UNITED STATES
NUCLEAR REGULATORY COMMISSION
WASHINGTON, D. C. 20555

PRELIMINARY REPORT
RELATED TO THE RESTART AND CONTINUED OPERATION OF
FORT ST. VRAIN NUCLEAR GENERATING STATION

Docket No. 50-267

Public Service Company of Colorado

Figure 3.3 Control Rod Driver Mechanism

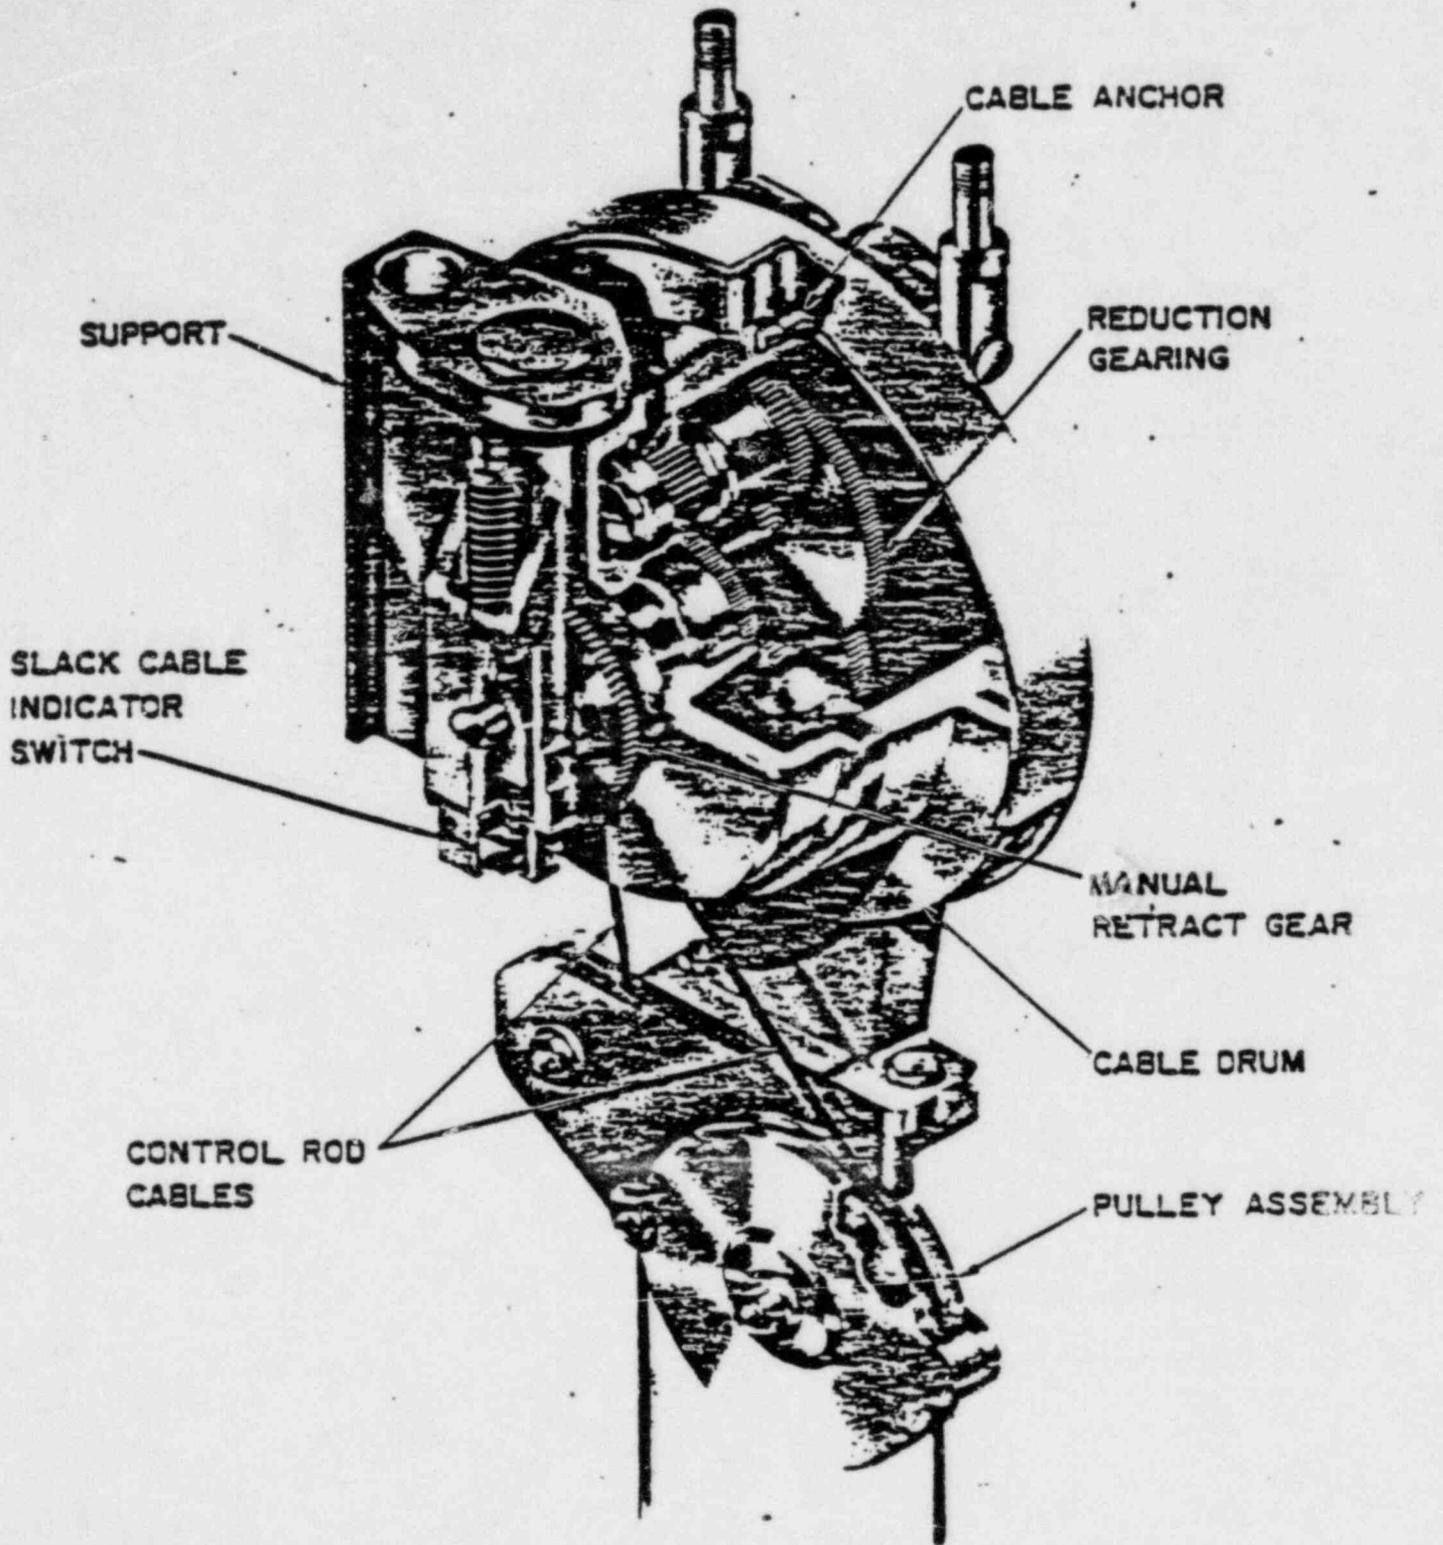
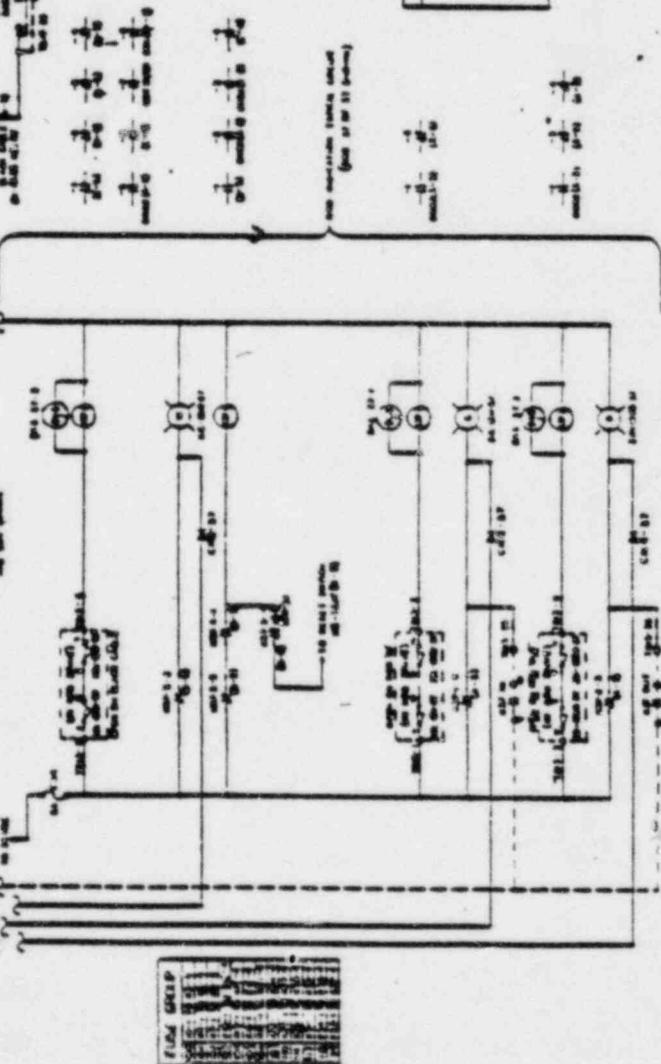
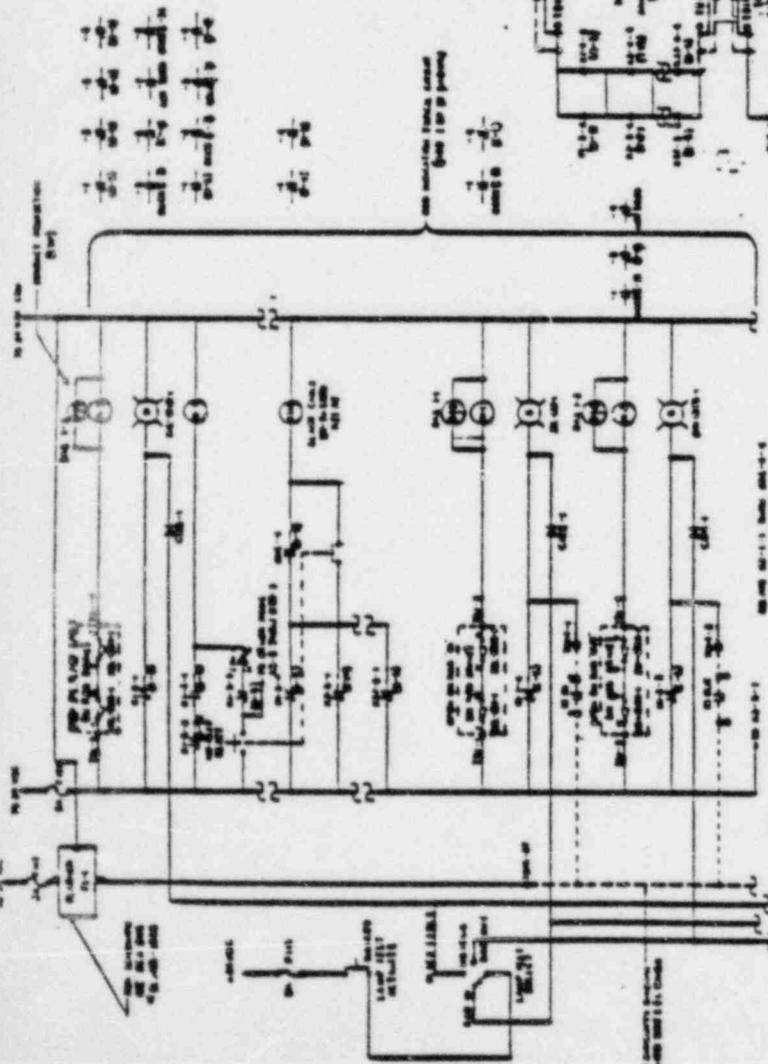
The slack-cable switch assembly shown in Figure 3.3 is provided for monitoring the tension in the cables supporting the control rod pair. The spring plunger exerts an upward force on the underside of the cable drum spindle, which counteracts the downward force caused by the control rod weight. In the event a control rod cable becomes slack, the upward force overcomes the control rod weight, and microswitches are actuated. Slack cable indication is signalled in the control room by both an alarm and a light.
